RE: Roberts' Improvements to Nenana Ave.

Re: Roberts Property – Nenana Avenue Sight Distance Analysis – Cannon Beach, Oregon
Technical Letter #1 – Supplemental Sight Distance Analysis

This transportation analysis supplements the September 12, 2020 Roberts Property – Nenana Avenue Sight Distance Analysis (Sight Distance Analysis) prepared by Clemow & Associates and addresses the September 22, 2020 City of Cannon Beach Nenana Avenue Plan Review #3 Memorandum prepared by Windsor Engineers.

Attachments: Figures 5, 6, and 7 – Sight Distance and Signing Figures

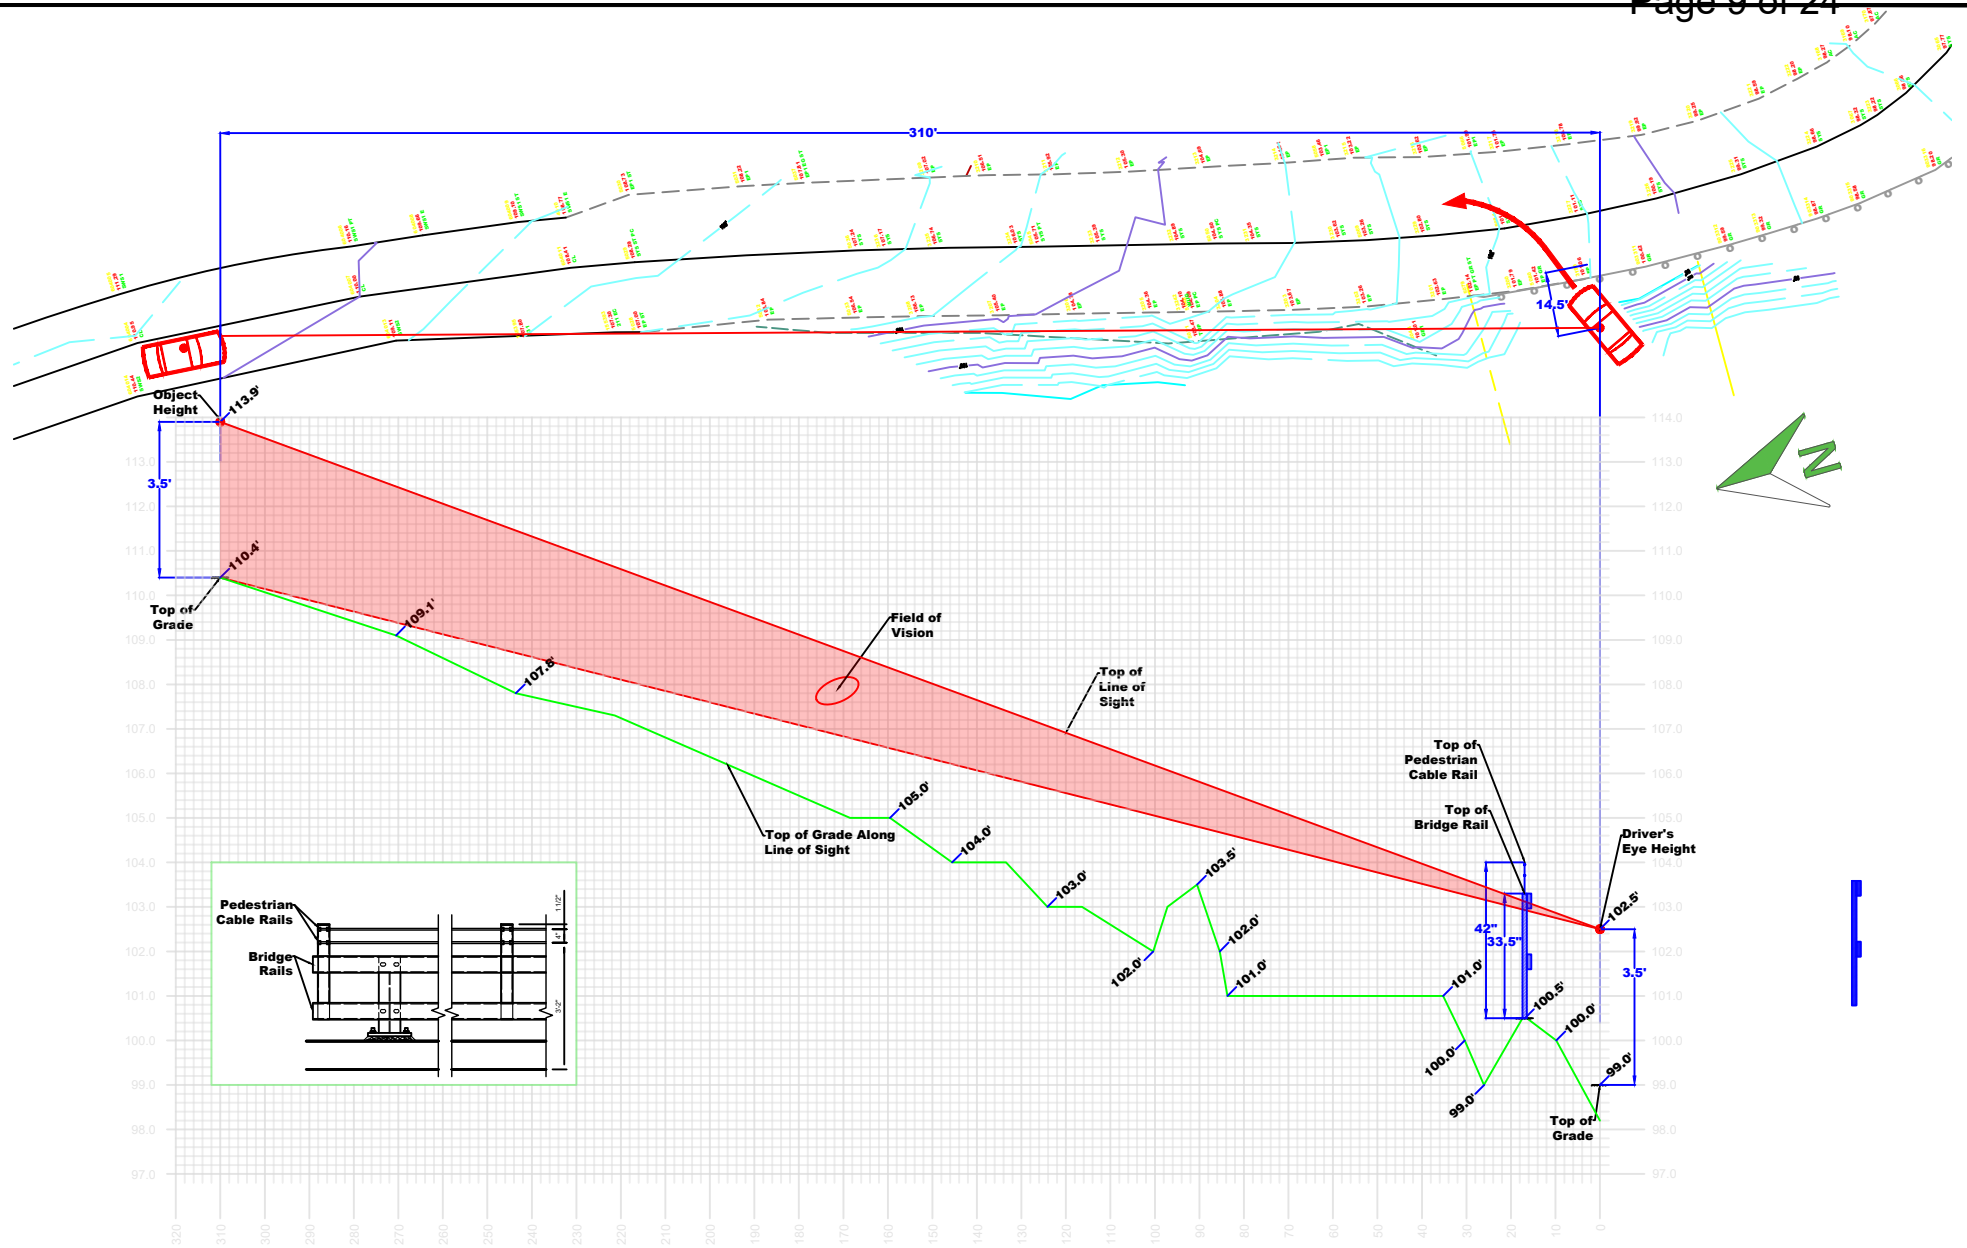
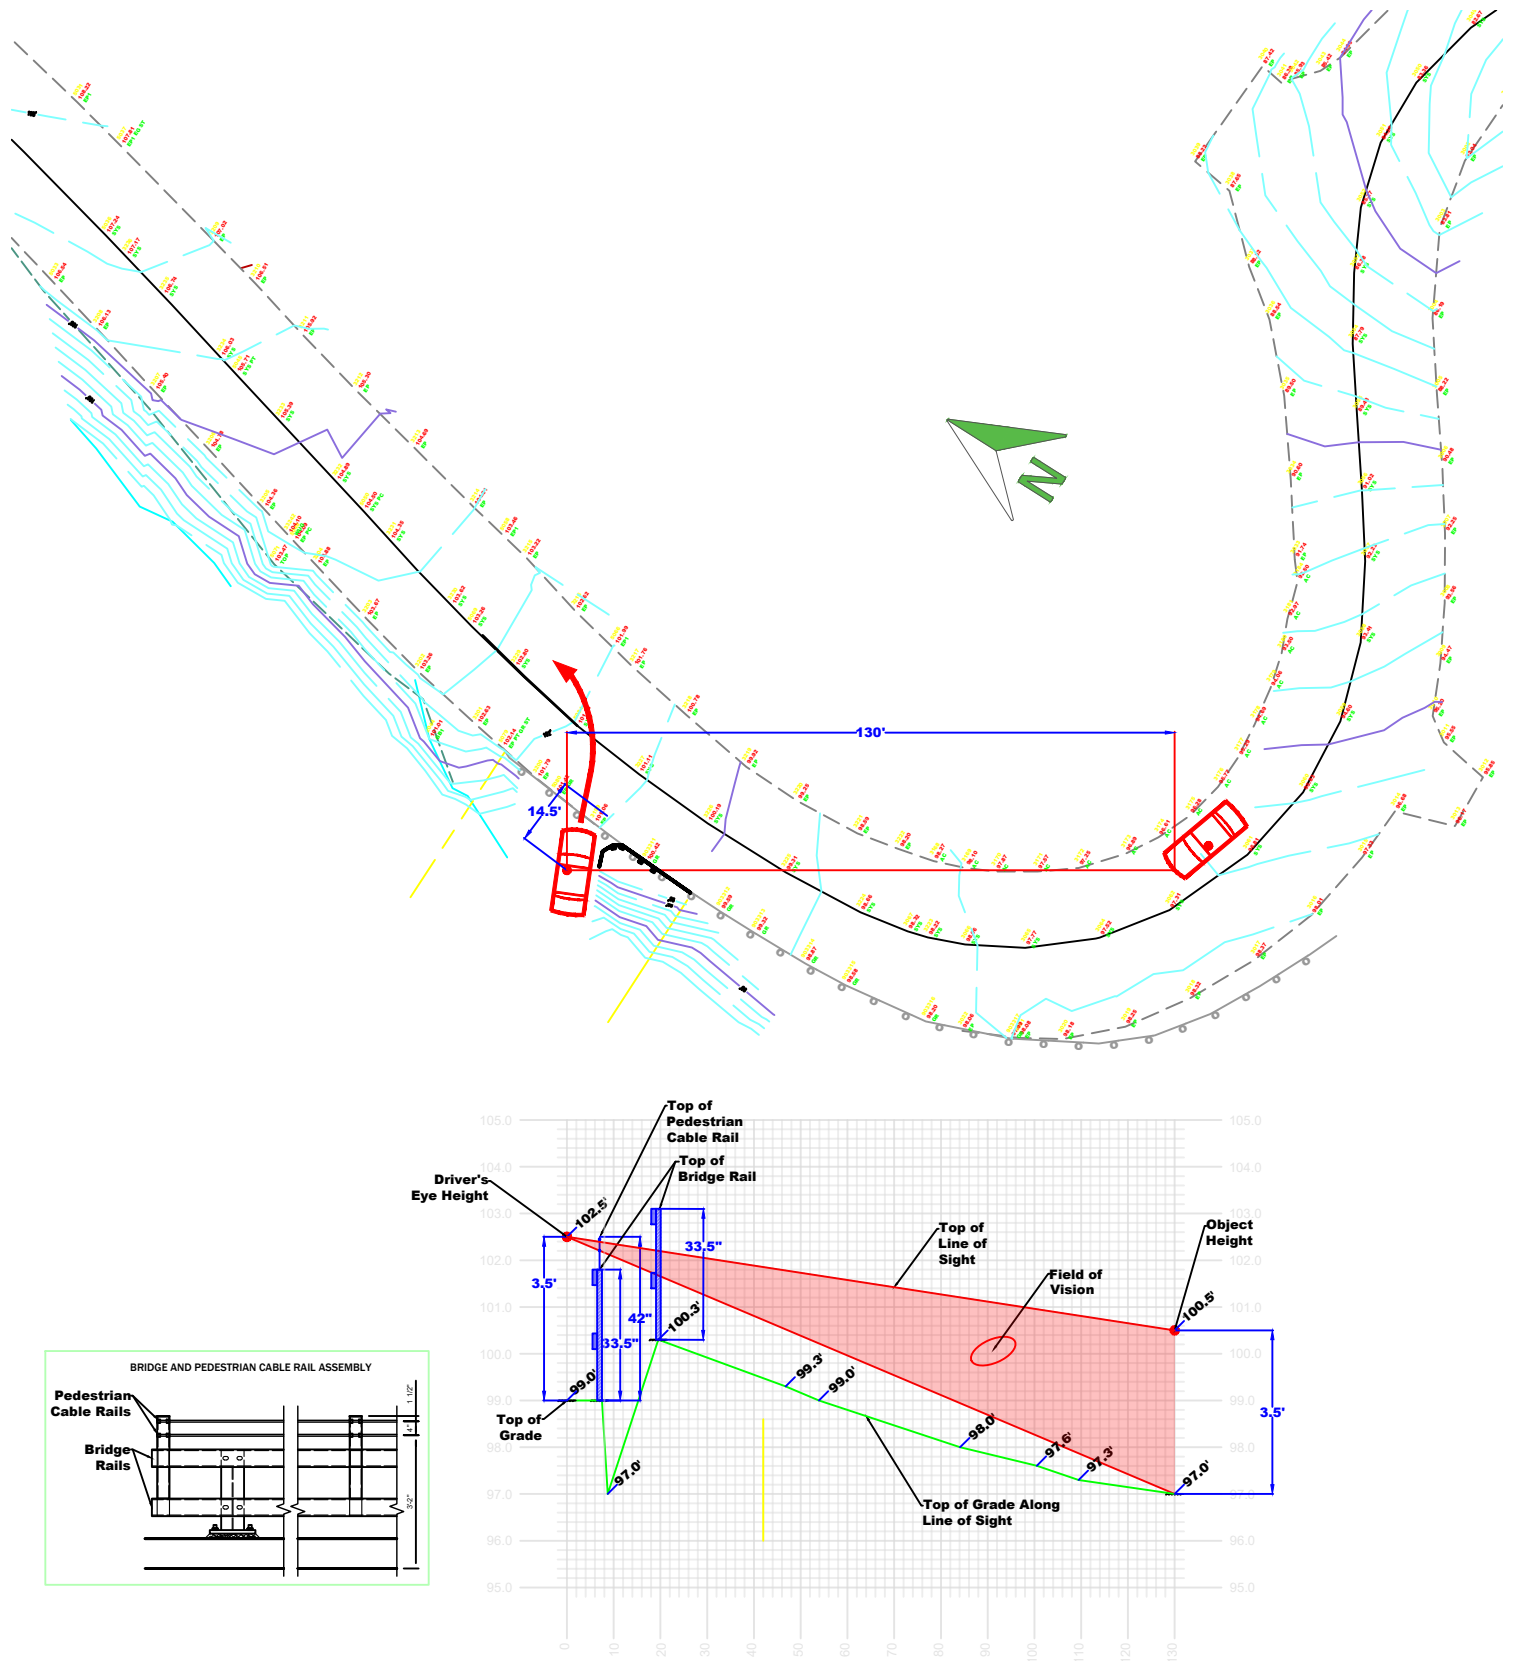
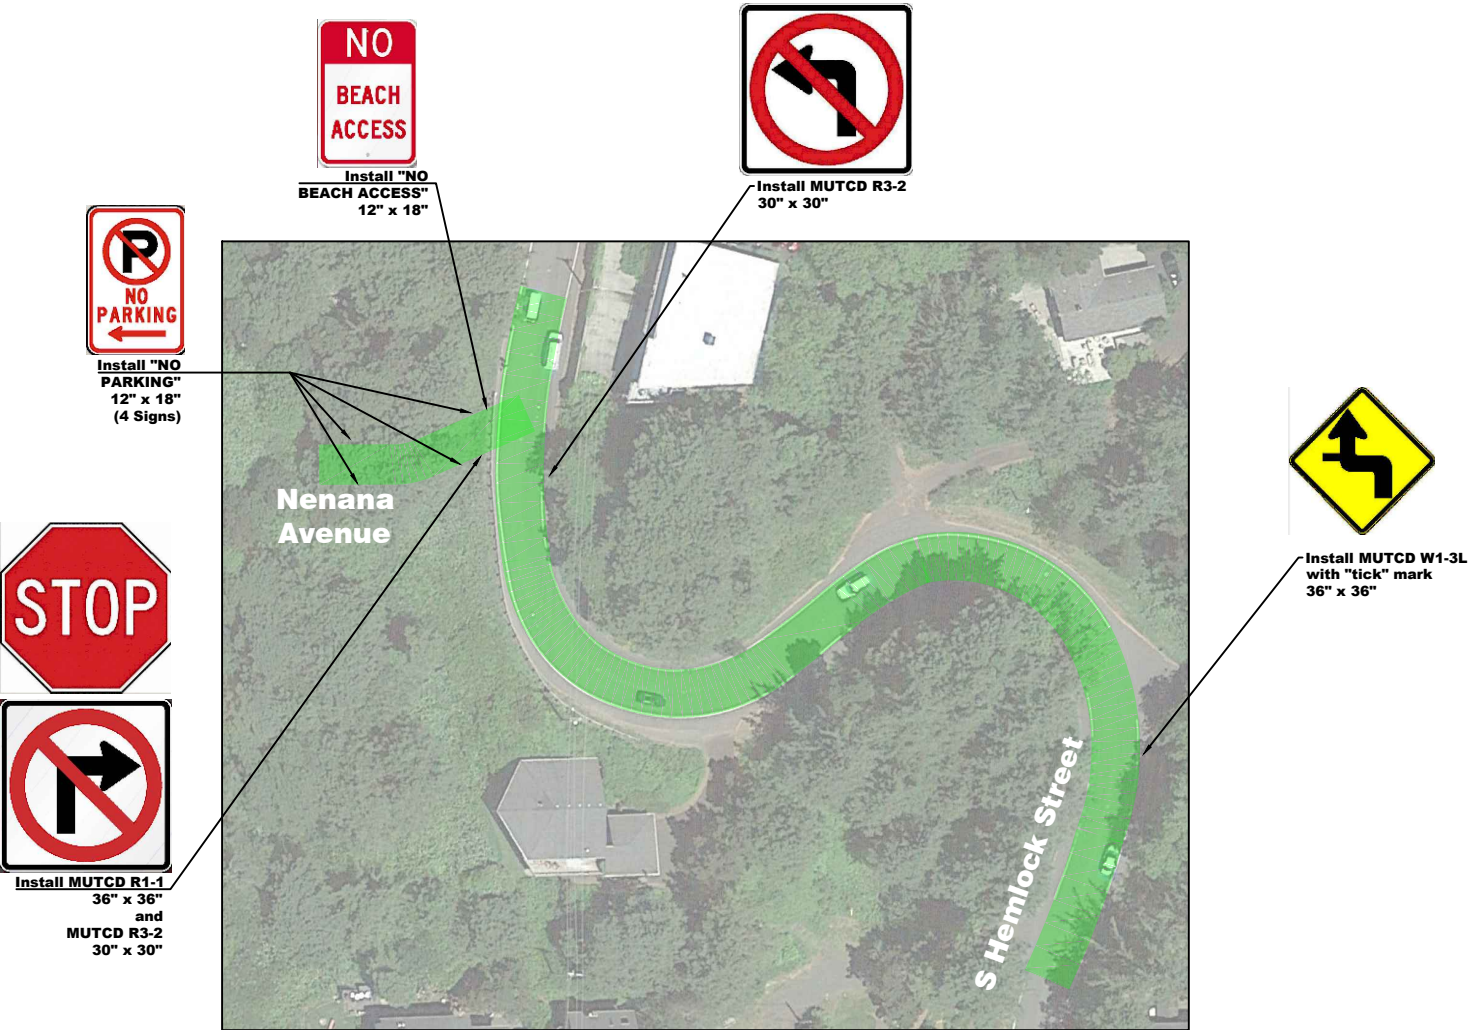
City Comment 6.2 states, *“Per the traffic study provided to Windsor on 9/14, the stopping sight distance (SSD) is adequate but the intersection sight distance (ISD) to the South is significantly less than the recommended distance. To further address sight distance, the Applicant shall:*

- Demonstrate the available ISD at a minimum scale of 1" = 20" using a sight distance triangle in the study. (Showing the driver's eye location, the vehicle outside of the travel lane, and the clear zone within the Clear Sight Triangle.)

Excerpt from traffic study, per [American Association of State Highway and Transportation Officials (AASHTO) A Policy on Geometric Design of Highways and Streets] AASHTO guidelines, ISD was measured from a driver's eye height of 3.5 feet and 14.5 feet from the edge of the nearest travel lane to an object height of 3.5 feet above the roadway surface.”

Applicant Response: Additional analysis has been performed and the attached Figures 5 and 6 – *Intersection Sight Distance – Left-Turn from Stop Plan and Profile* have been prepared measuring sight distance per AASHTO guidelines, with the following additional summary comments:

- At the proposed Nenana Avenue access location, a section of existing guardrail adjacent to Hemlock, within the Nenana right of way, will be removed.
- On the north side of Nenana, a new guardrail will be installed, connecting to the bridge rail and extending a short distance adjacent to Hemlock. This guardrail section is not within the driver's line of sight when considering intersection sight distance (ISD); therefore, it does not obstruct ISD.

- On the south side of Nenana, the bridge rail will extend approximately 15 feet to the south adjacent to Hemlock. This bridge rail section is within the driver's line of sight when considering ISD; however, as illustrated in the bridge rail standard detail (submitted separately), the design allows a driver to 'see through' the bridge rail. Therefore, the bridge rail does not obstruct ISD.

- On both the north and south sides of Nenana, the bridge and pedestrian rails are within the driver's line of sight when considering ISD; however, as illustrated in the bridge and pedestrian rail standard details (submitted separately), the design allows a driver to 'see through' the rails. Therefore, the bridge and pedestrian rails do not obstruct ISD.

- Consistent with findings contained in the *Sight Distance Analysis*, ISD is not met for an eastbound left-turning vehicle looking to the south (but it is not further obstructed by the bridge and pedestrian rails, or the guardrail). However, stopping sight distance (SSD) is met for a northbound vehicle on Hemlock and it is anticipated the turning movement will operate safely.

As identified in the attached Figure 6, the applicant is recommending several traffic control signs to be installed with the construction of Nenana. It is recommended the City consider the installation of these signs to alert motorists on Hemlock of the Nenana intersection, to prevent unsafe turning movements, and to prevent parking on Nenana. It is further recommended that all sign installations be consistent with existing City signing standards.
